**WHEELING PLAN COMMISSION
THURSDAY, AUGUST 24, 2017 6:30 P.M.**

RE: **Docket Nos. PC 17-14 and SCBA 17-31**
Burger King
425 W. Dundee Road
(PC 17-14) Site Plan Change to Special Use Ordinance No.
1997 for Building and Site Modifications to an
Existing Drive-Thru Restaurant
(SCBA 17-31) Appearance Approval of Wall Signs

At the August 10, 2017 Plan Commission meeting, Docket Nos. PC 17-14 and SCBA 17-31 were tabled so that the petitioner could address the following suggestions made by the Plan Commission (**staff update provided in bold**):

Re: Burger King 3953 Remodel
425 W. Dundee Road
Response to Recommendations and/or Conditions on Decision and Comment Form

LANDSCAPE PLAN

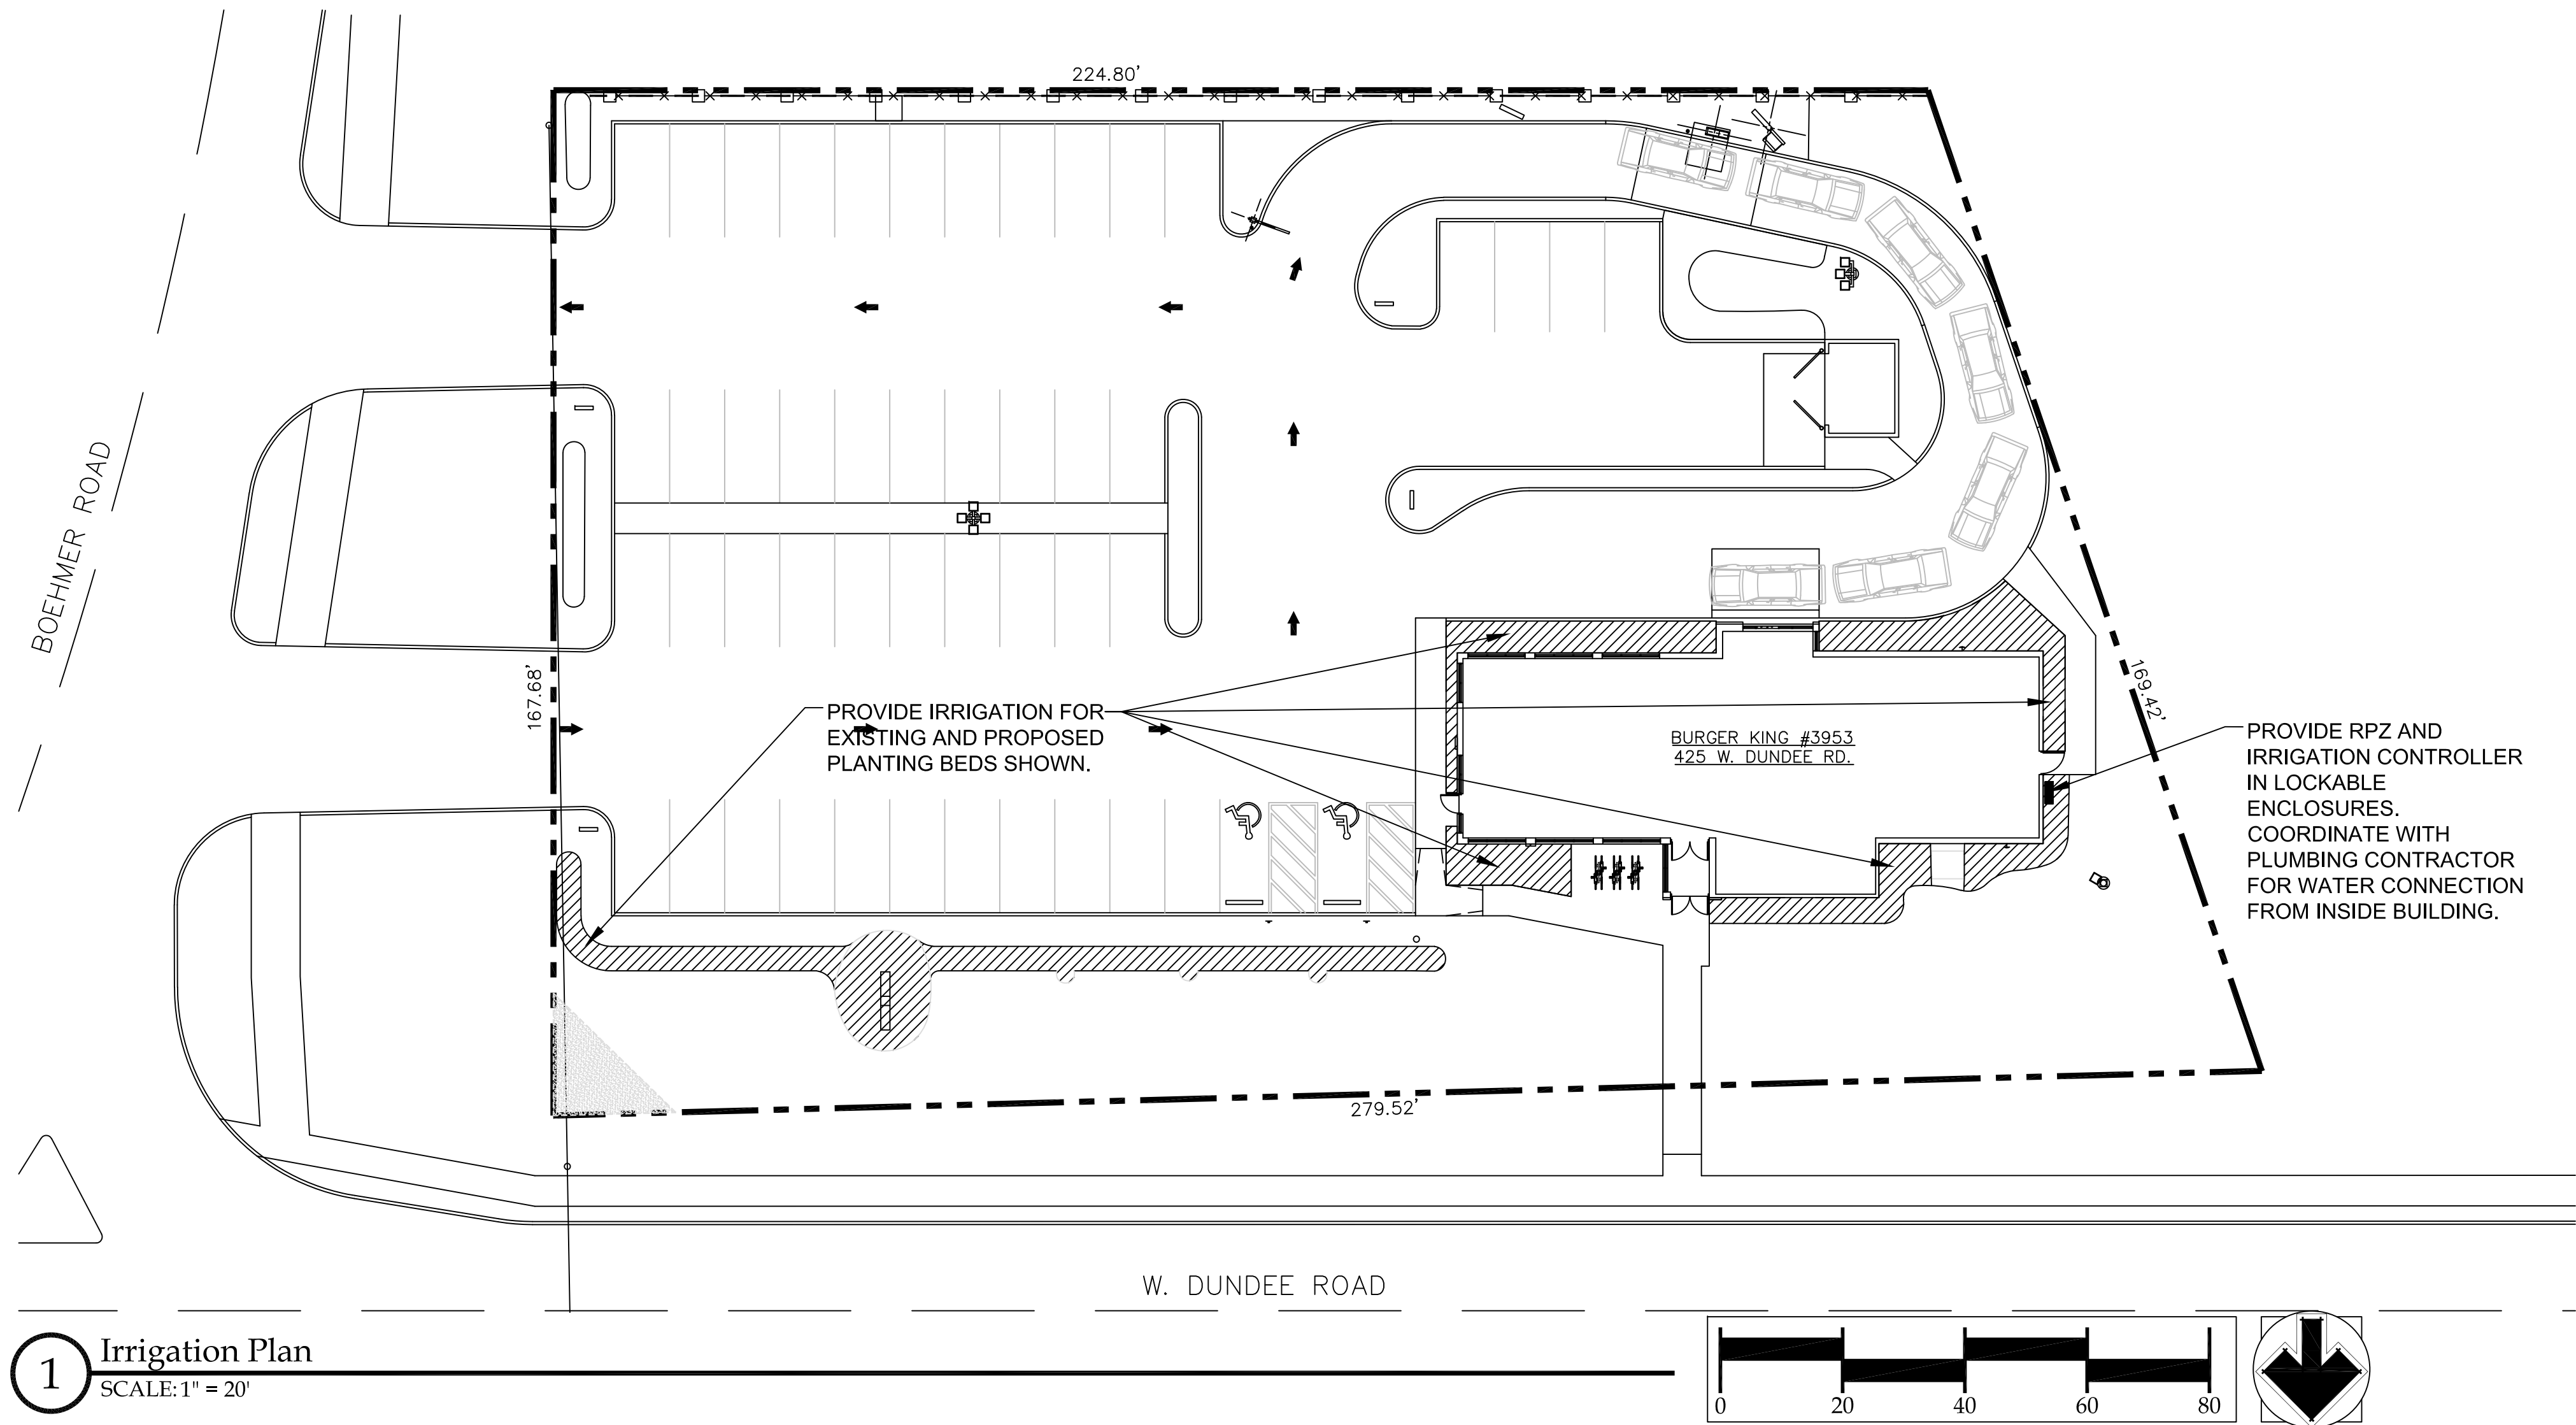
Landscape Irrigation: As requested by the Plan Commission on August 10th, the applicant is proposing to irrigating plantings, excluding parking lot islands. An irrigation plan is provided on [Sheet L2](#).

3. An Irrigation Plan has been provided. See Sheet L2. The plantings, excluding any islands, will be irrigated.
4. We have addressed all maintenance concerns by eliminating the painting of the existing face brick on the exterior of the existing building and on the exterior of the existing trash enclosure. We will be covering all the existing face brick with Nichiha panels (EF-1G & EB-1AG) as shown on the updated exterior elevations. The existing trash enclosure will be covered in the same materials. All new Nichiha brick panels (EB-1AG) will not be painted. See updated exterior elevations and Sheet SP-1 for more information. I have also included exterior photos from a previously completed Burger King remodel in Shorewood. The Shorewood location is very similar to what we are proposing for this Wheeling location.
